Re: Oral and Written Ex Parte Presentation in IB Docket No. 00-248

Attachment – Proposed revision to 47 CFR Part 25.138

IB Docket No. 00-248 – QUALCOMM’s Proposed Revision to Part 25 to Accommodate Broadband Systems Employing Random Access Technologies in the 20/30 GHz Band

θ° from Terminal Antenna Boresight

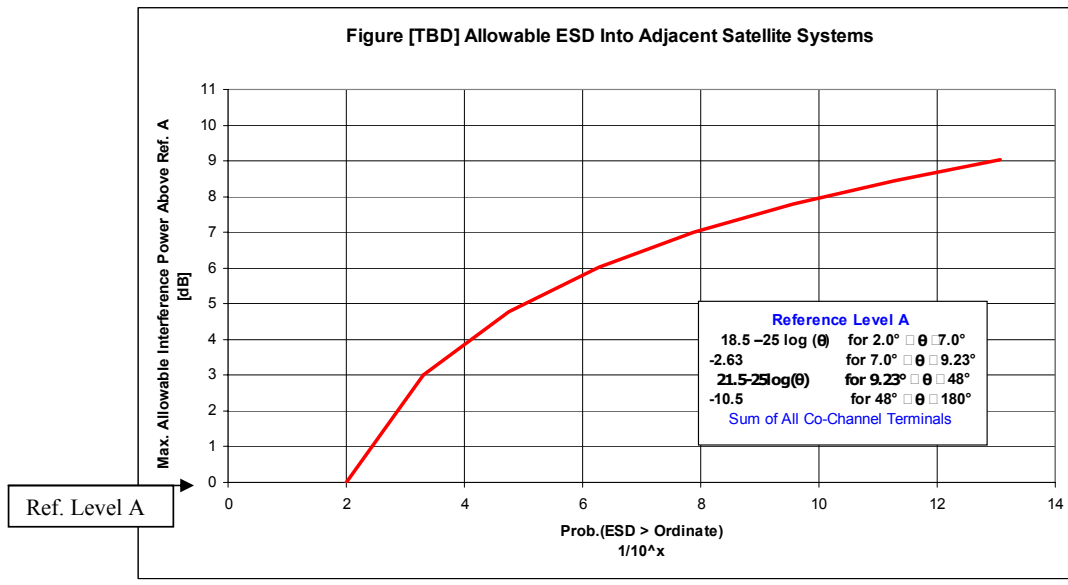
(a) the total number of simultaneously transmitting co-frequency GSO FSS earth stations operating in all beams of one satellite system generate an off-axis EIRP spectral density for co-polarized signals (when directing their power within $\pm 3^\circ$ of the GSO arc and under clear sky conditions) in accordance with the figure below.

[Note: the values on the X axis should be expressed as $10^2=0.01$, $10^4=0.0001$, etc.]
